ADDENDUM 02

Date: June 17, 2024

Project: HISTORIC HALIFAX VISITOR CENTER RENOVATION
SCO #: 22-24955-02B

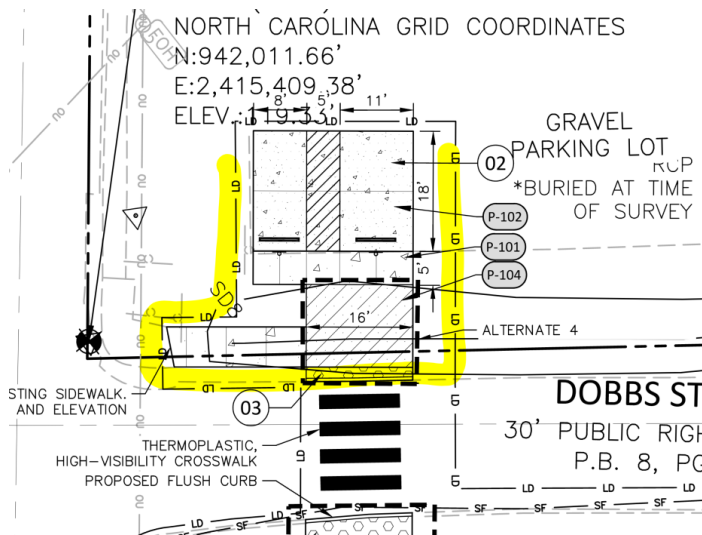
ITEM 11: Will any temp fencing be required for the parking lot across the street?

ANSWER: Silt fence is required at the parking lot across the street as highlighted below:

ROOF PLAN

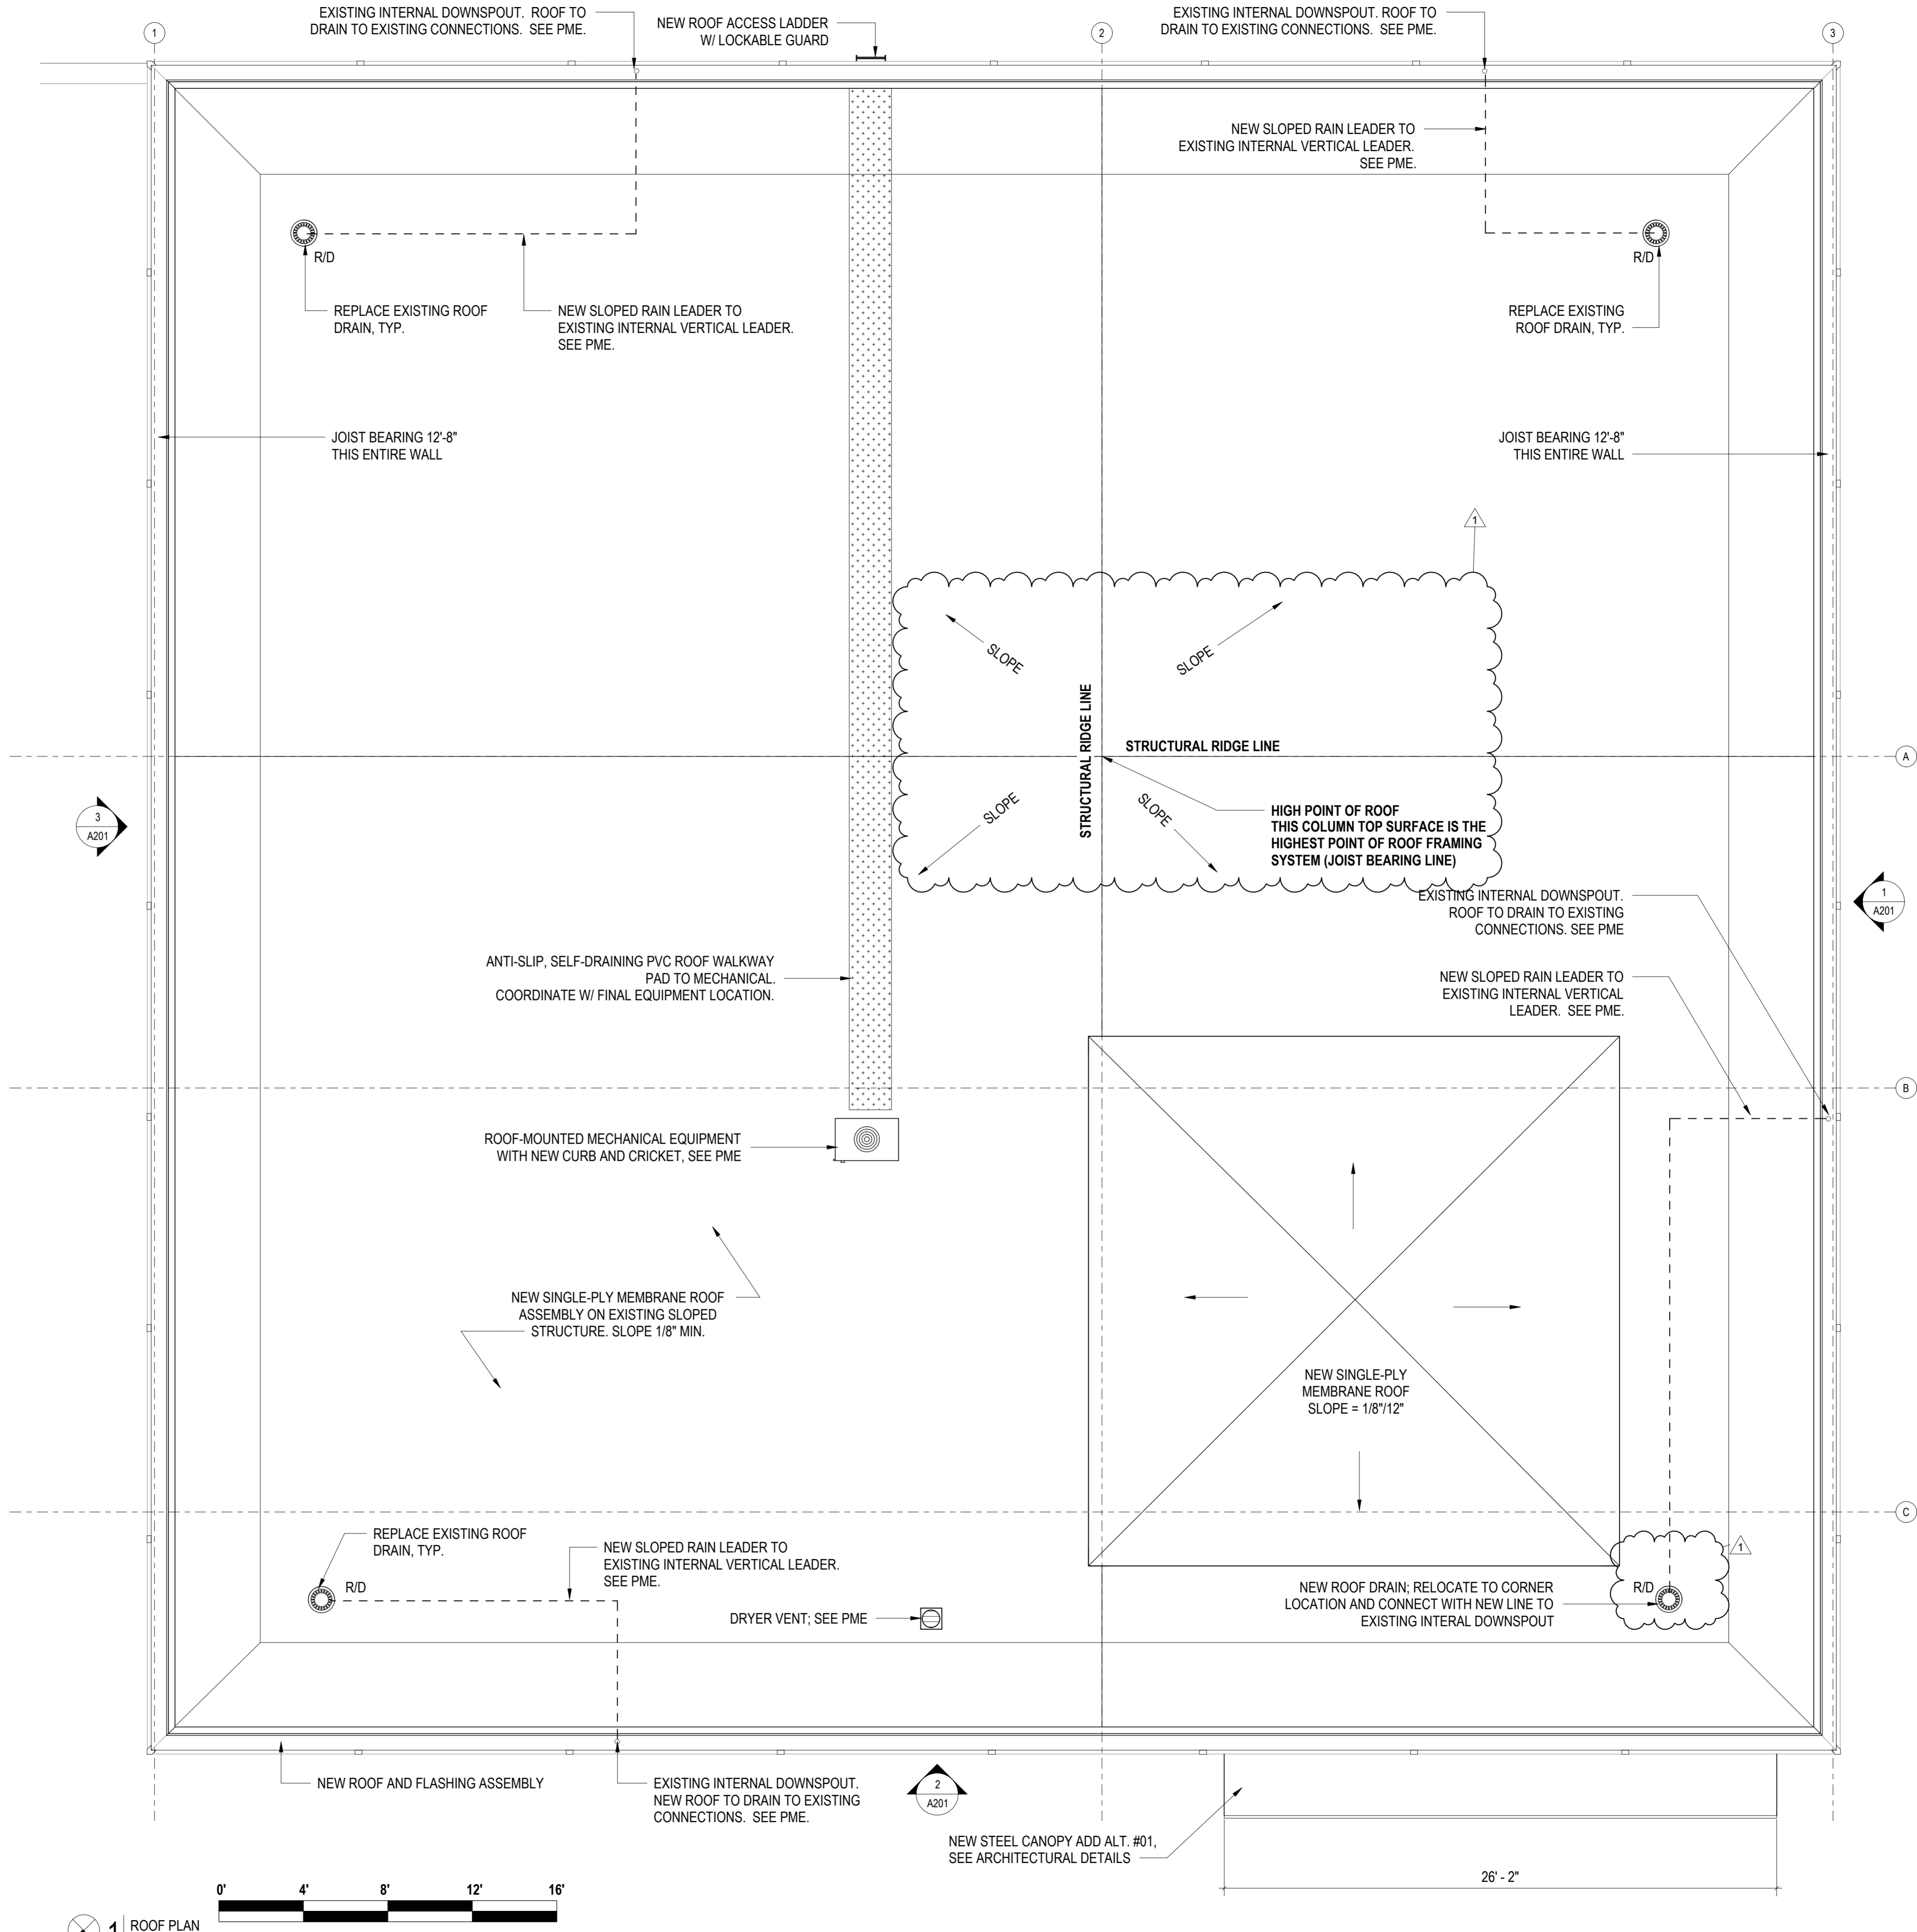
ITEM 1: REVISION

See attached for revised Architectural Roof Plan, to be included in IFC set
